Applicant : Andrew M. Weiner
Serial No. : 09/865,028
Filed : May 24, 2001
Page : 16 of 21

Amendments to the Drawings:

The attached replacement sheets of drawings includes changes to Figures 4a and 4b and replaces the original sheets including Figures 4a and 4b.

Figure 4a

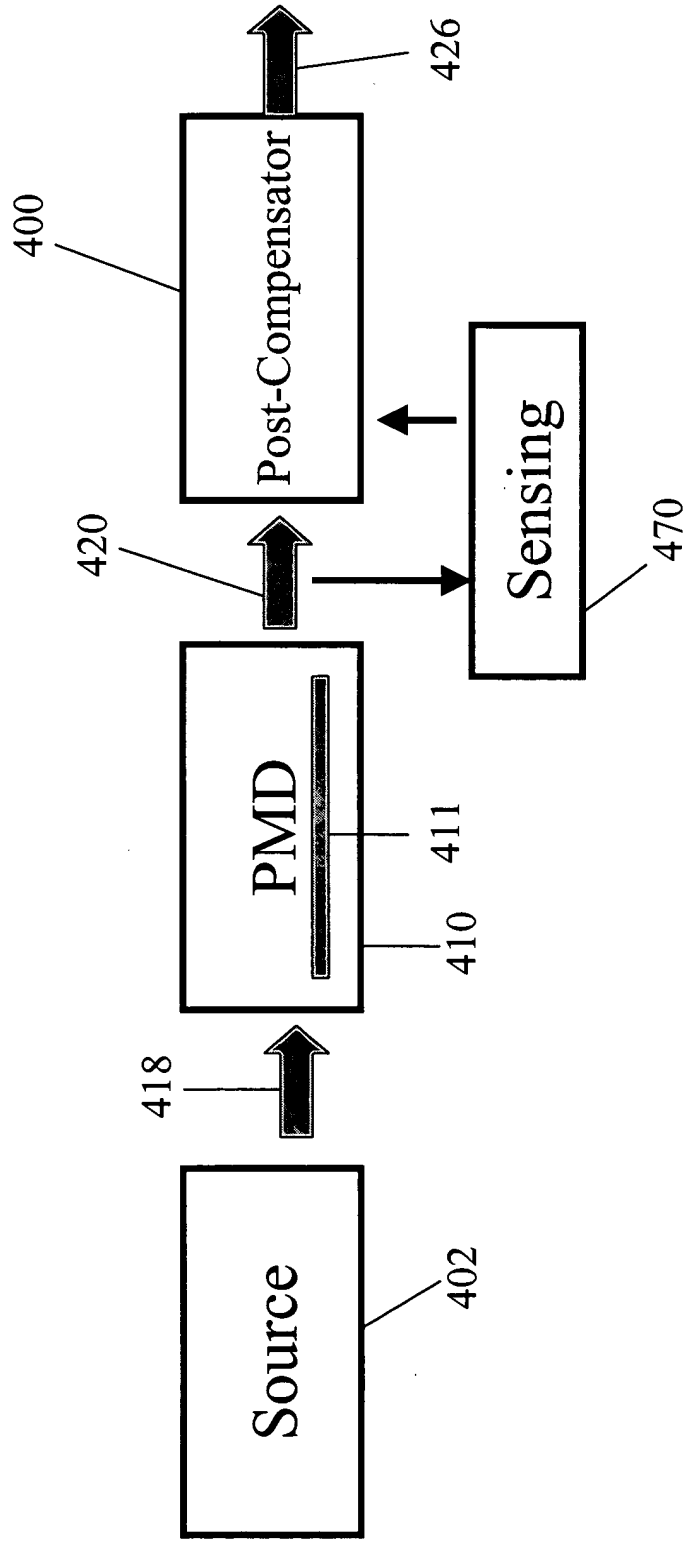
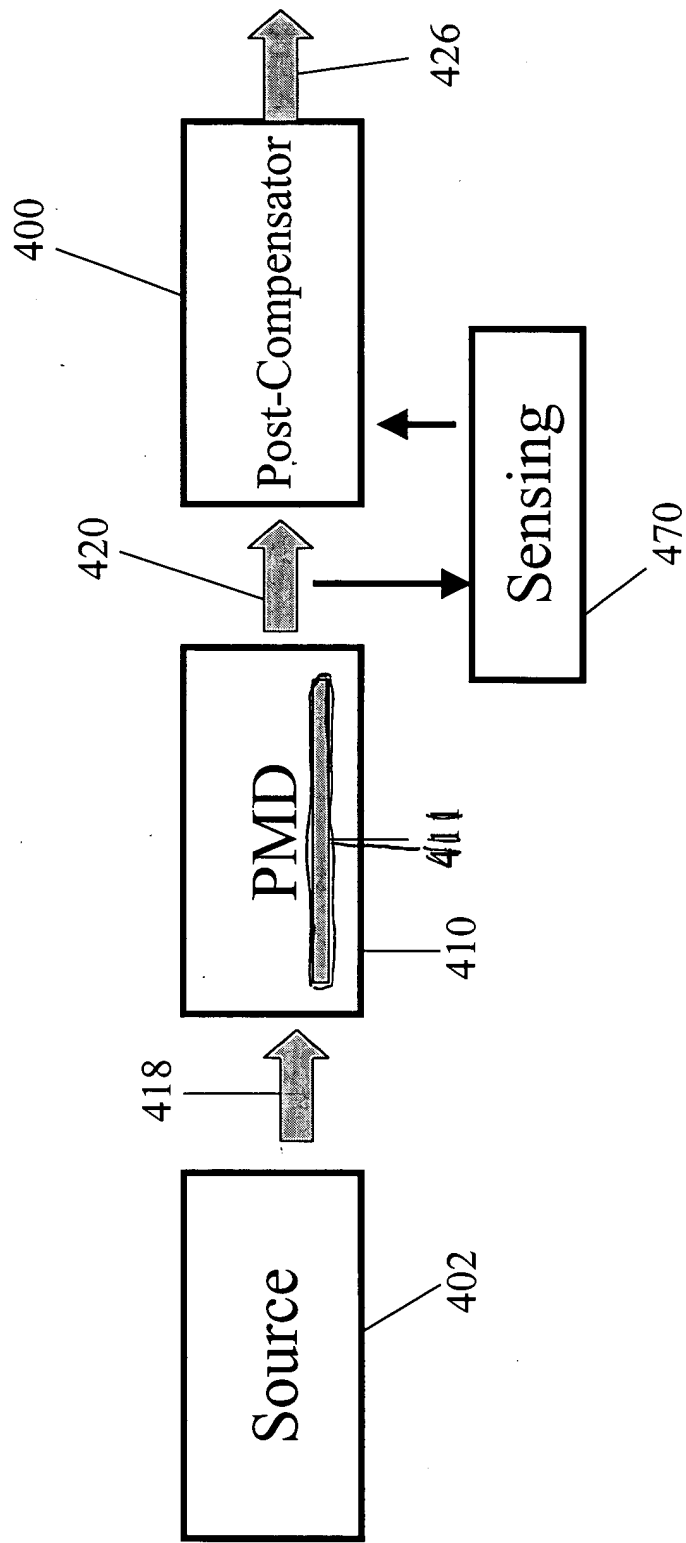
In Figure 4a, optical fiber 411 has been explicitly shown to be a component of optical system 410. Similarly, in Figure 4b, optical fiber 411' has been explicitly shown to be a component of optical system 410'.
